## Development Review Division

**TO:** Madeleine Reinke, Kimley-Horn and Associates, Inc.  
**FROM:** Cynthia Thye, Planner 1  
**DATE:** December 31, 2025  
**SUBJECT:** SP25-119: Lincoln Professional Park L2 - 7 Brews Coffee – Site Plan Review Comments 02

**LEGEND**

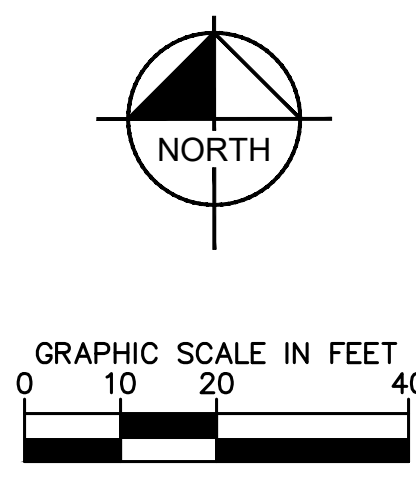
Add legend for hardscaped surfaces and materials.

Understood, hardscaped surfaces and materials have been added to the legend.

PROJECT NO.  
 296237001  
 SHEET  
 296237001\_SP  
 3

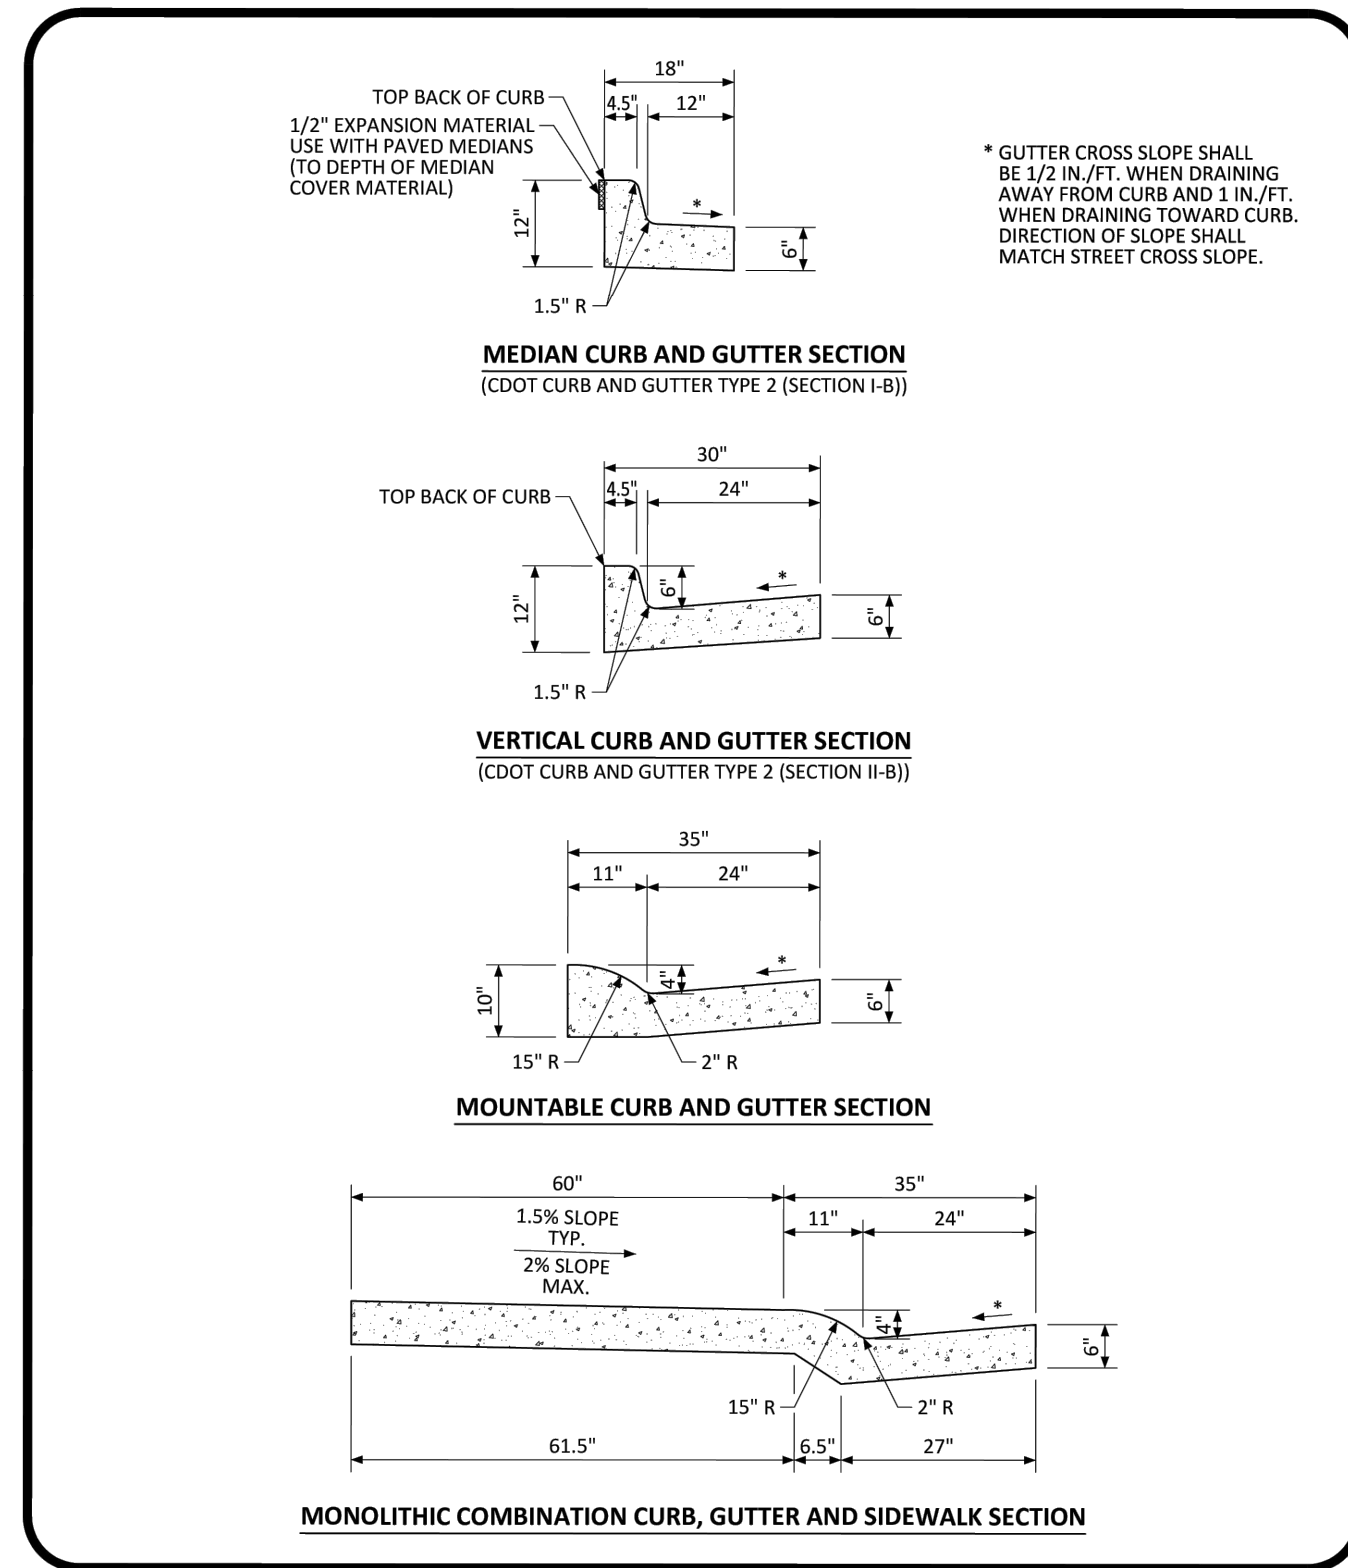
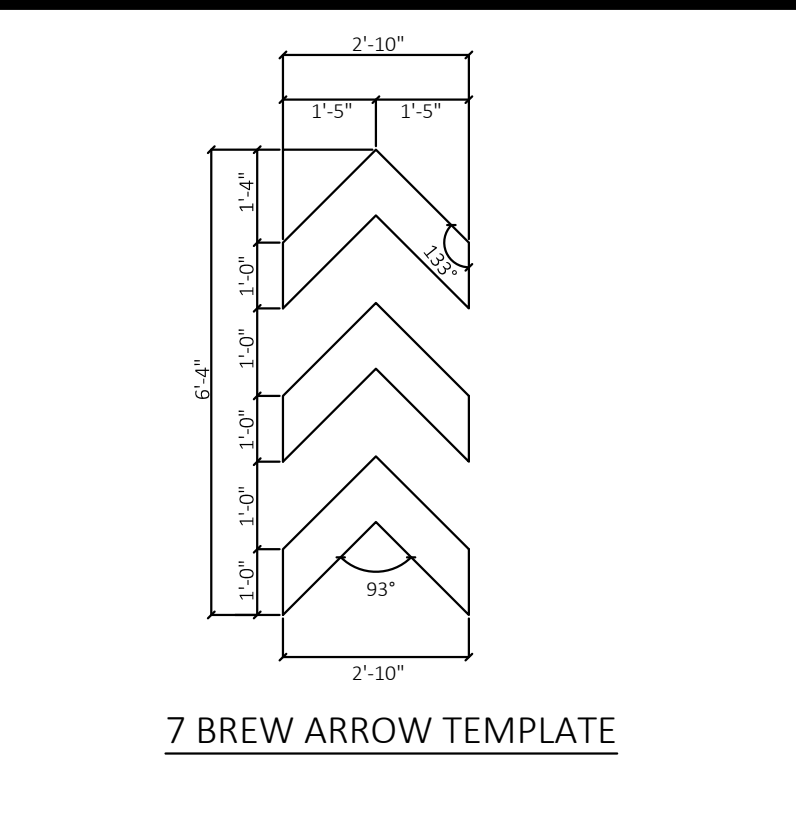
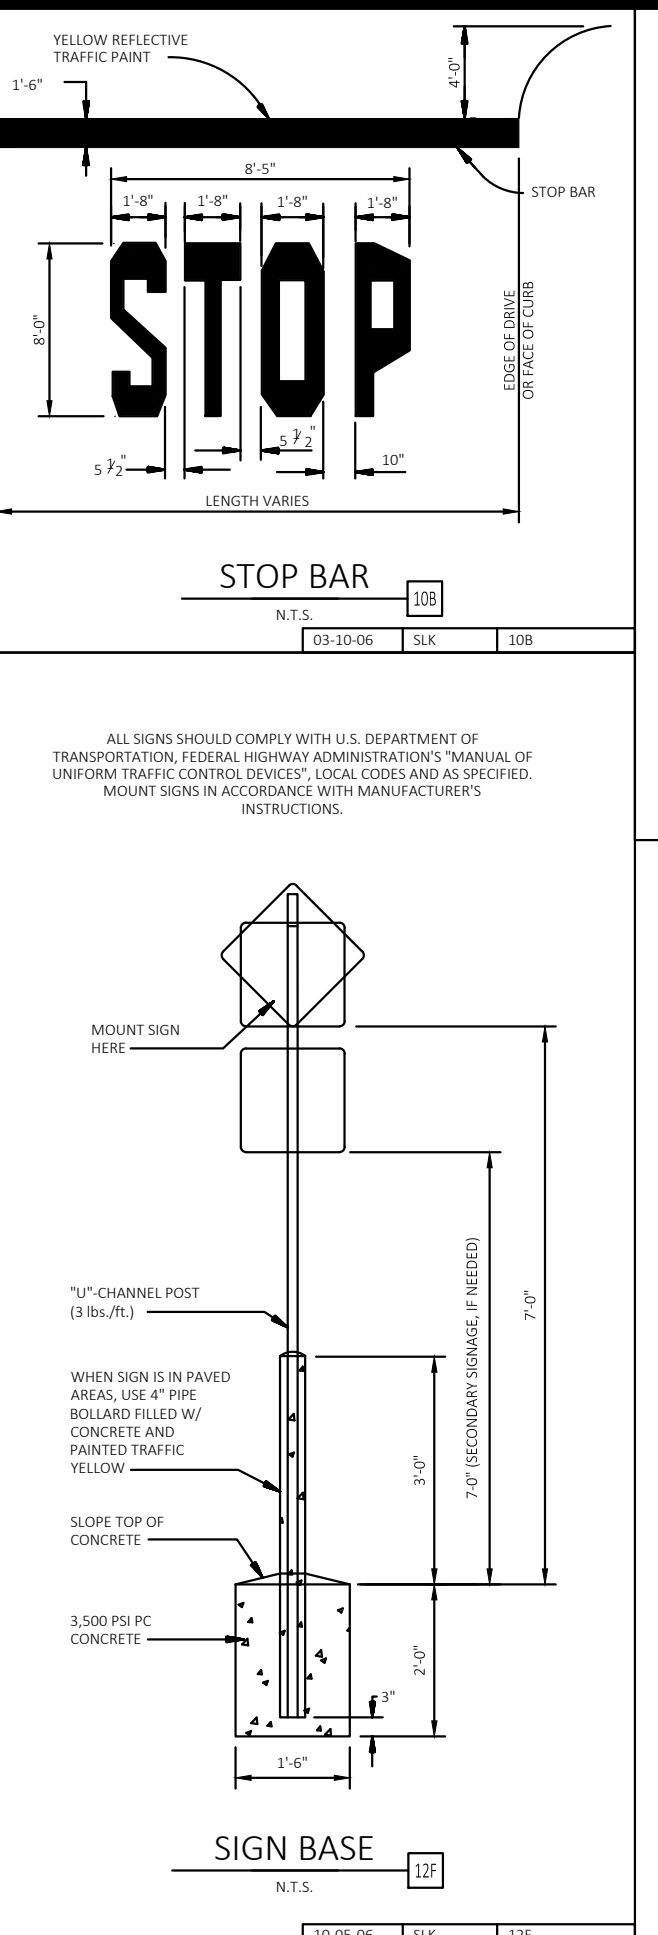
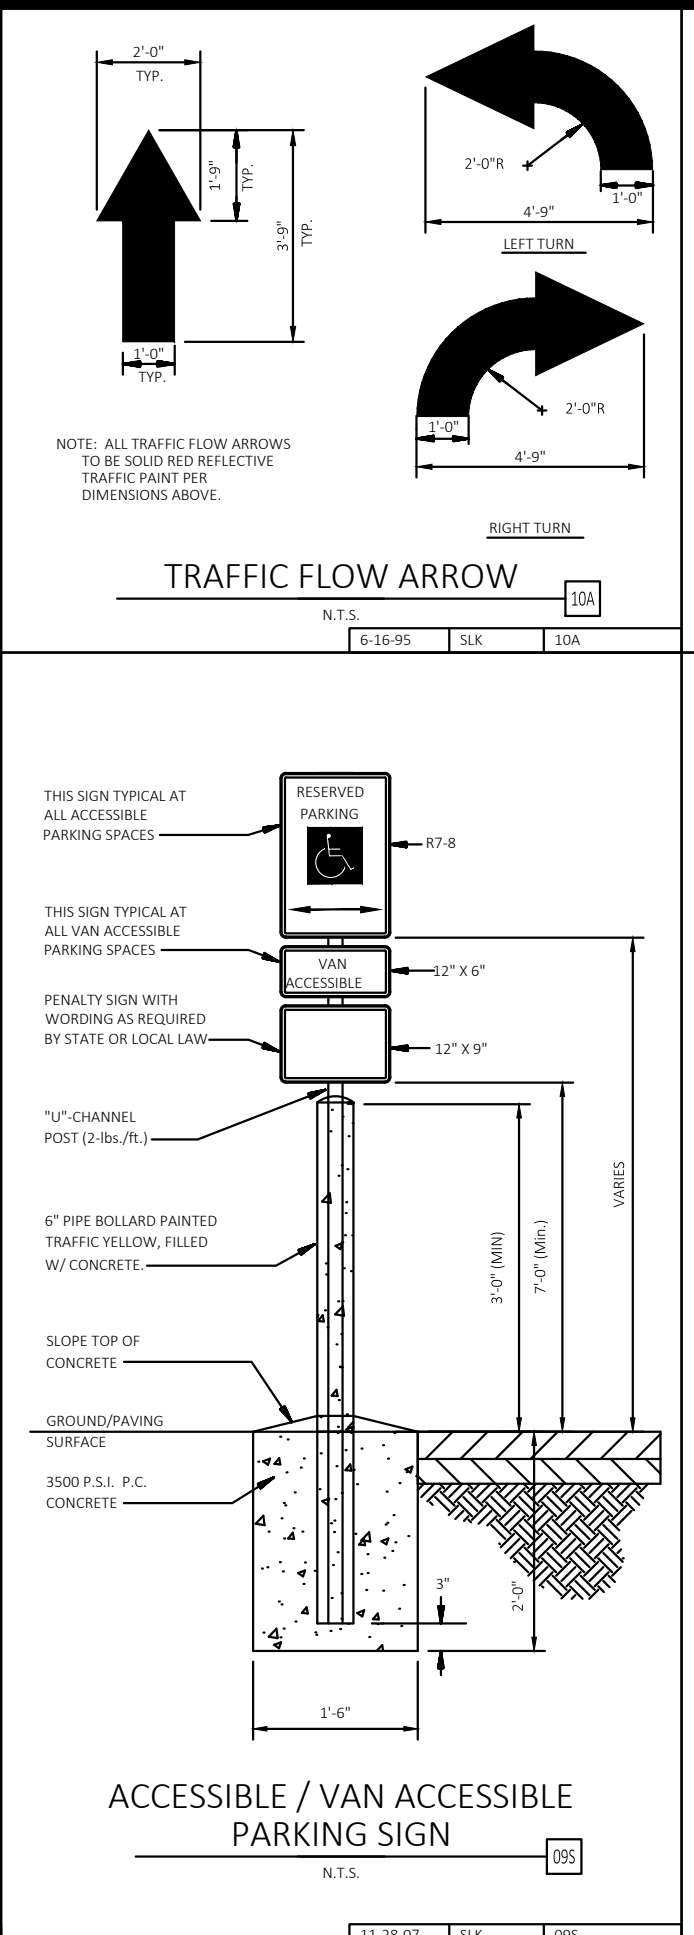
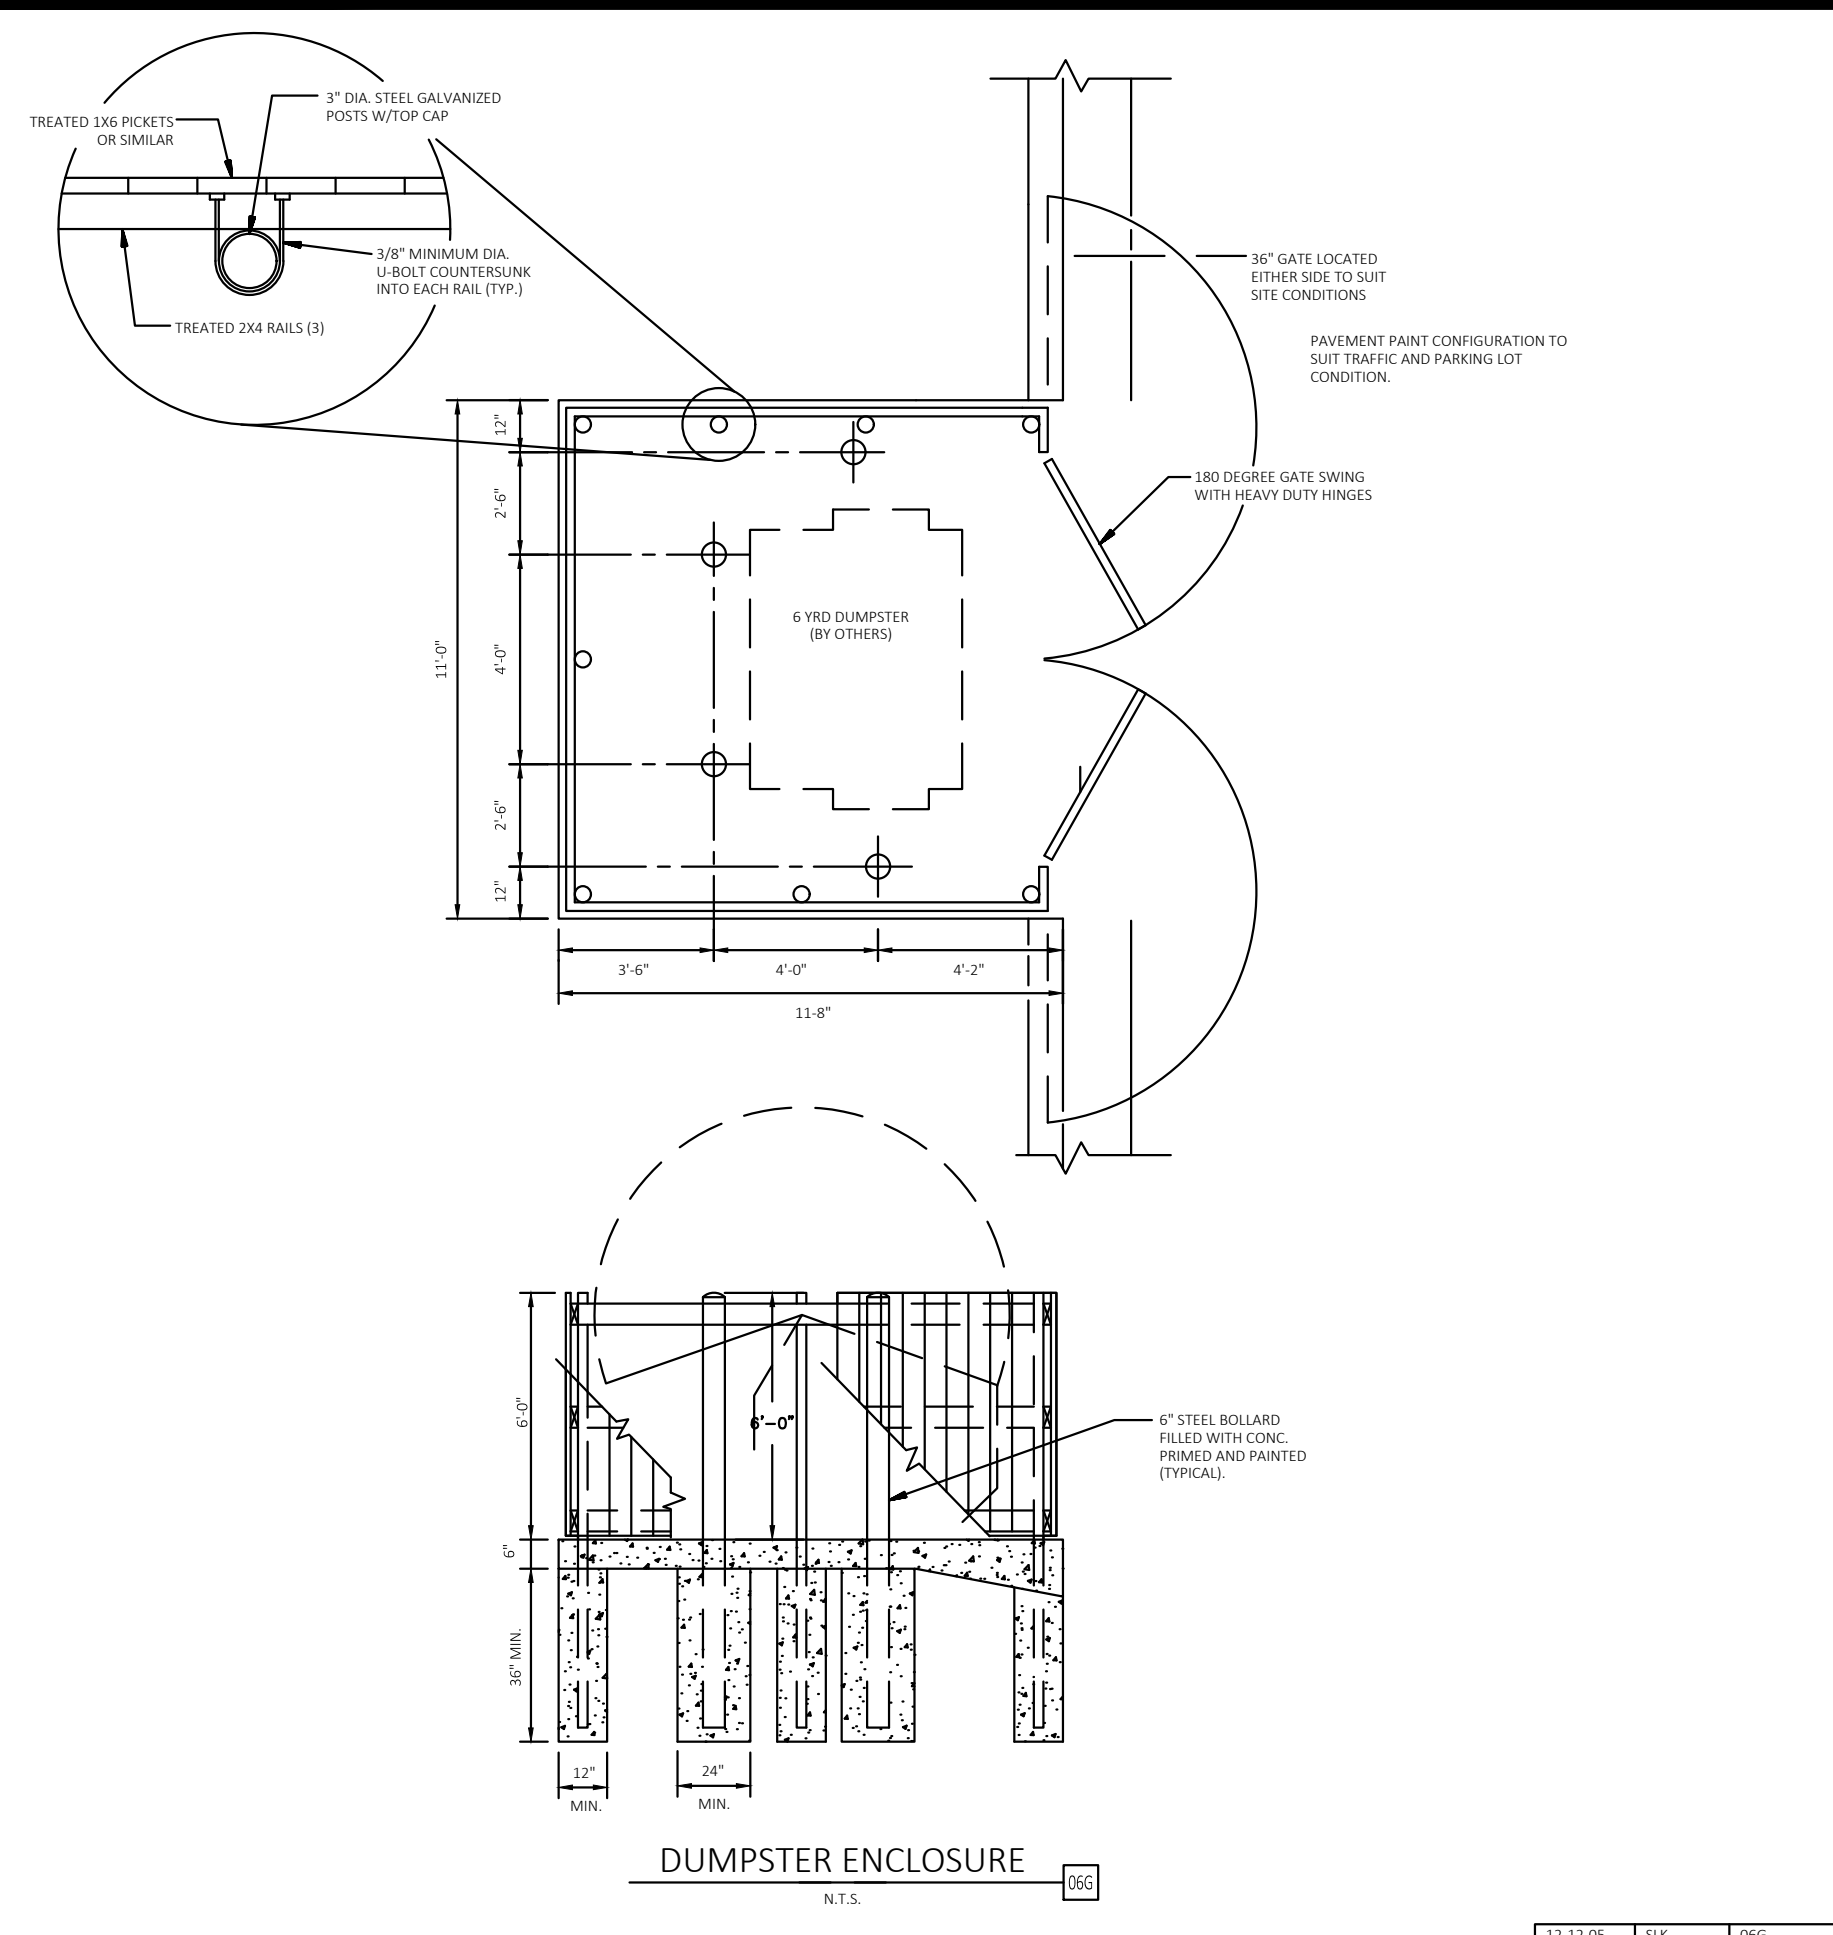
Per LDO Administrative Manual, Page 25 indicate # feet from building to property line.

Understood, a dimension showing the distance from the building to the property line on all four sides has been added.

PROJECT NO.  
 296237001  
 SHEET  
**L2.0**

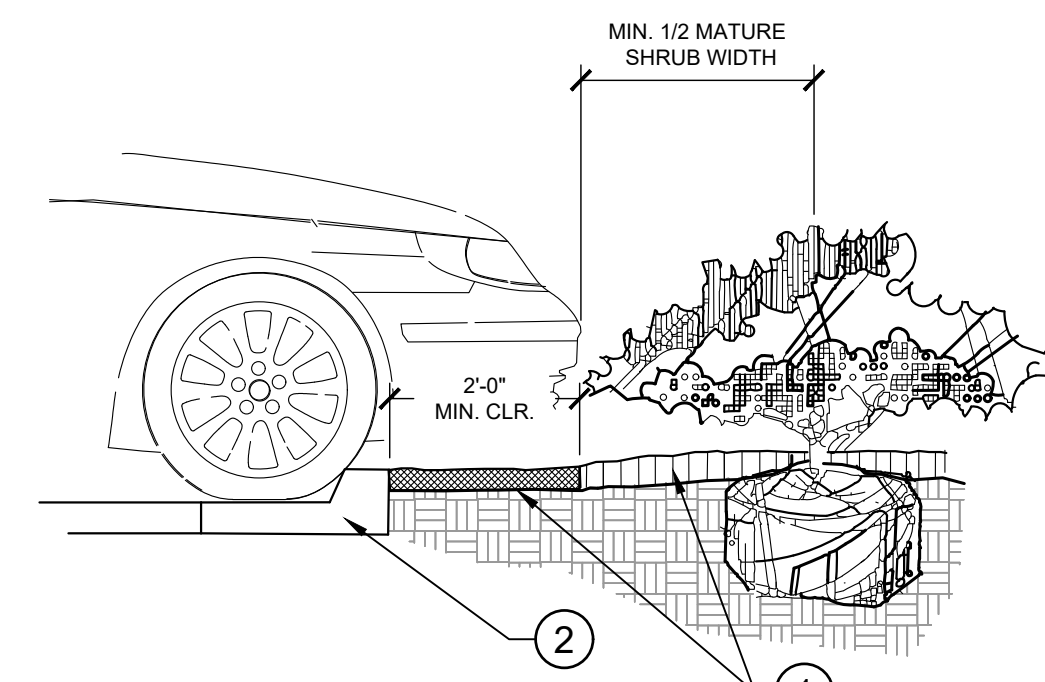
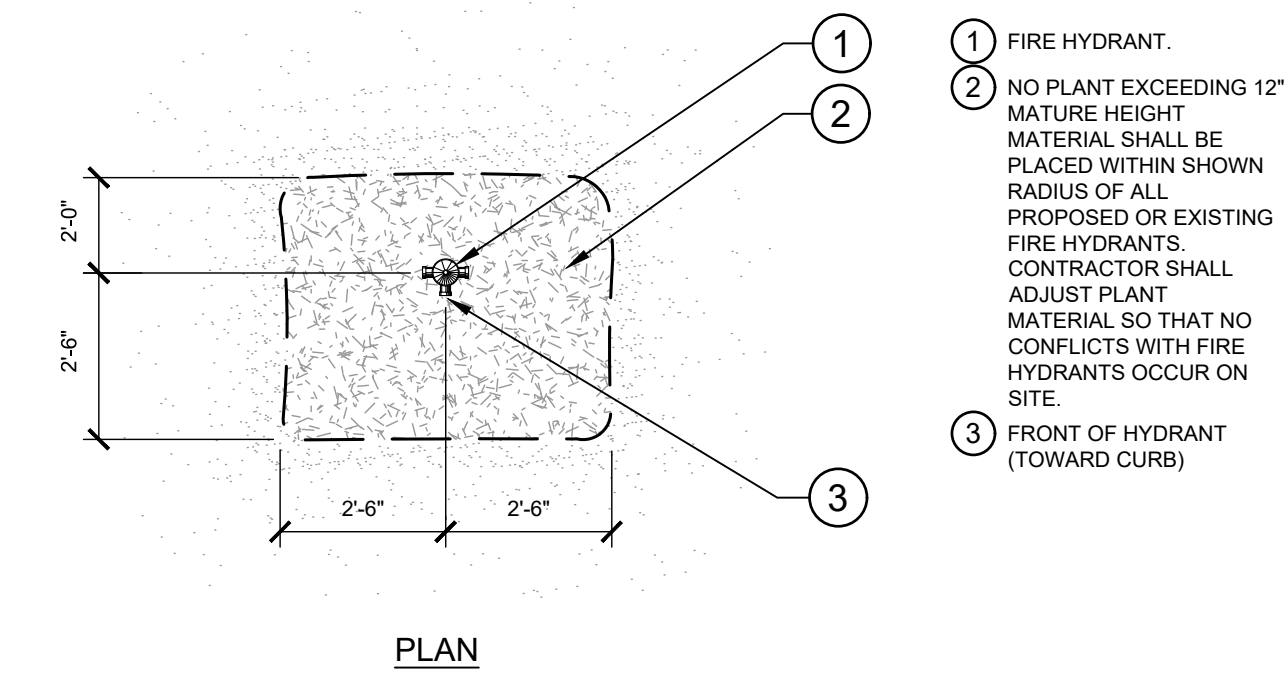
Revise - in Mixed Use Community - 1 tree per 40 linear feet. KH RESPONSE: Street trees updated to reflect 1 tree per 40 lf.

Per LDO 13.08.090(h) Add Site Interior Landscaping category if parking lot and perimeter landscaping do not collectively meet min. landscaping requirement. KH RESPONSE: Minimum landscape requirements have been met.
